Transport for NSW  
Western Harbour Tunnel and Warringah Freeway Upgrade  
30 March, 2020

I am writing to object to the proposed Western Harbour Tunnel and Warringah Freeway Upgrade as they have a direct affect on the liveability of our property at 2 Bray St, North Sydney and the surrounding neighbourhood.

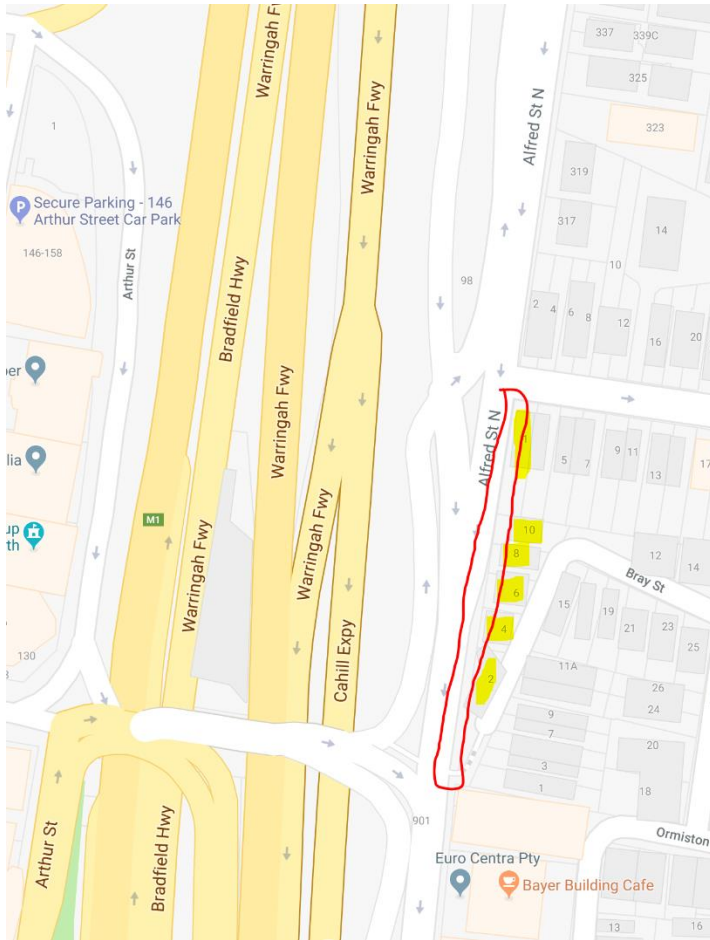
- Prior to road works construction starting, construct a noise proof barrier/fence between Alfred Street North and properties fronting Bray Street, presently there is an inadequate timber paling fence which will not provide adequate noise abatement, see map below highlighting the section requiring a noise proof fence.
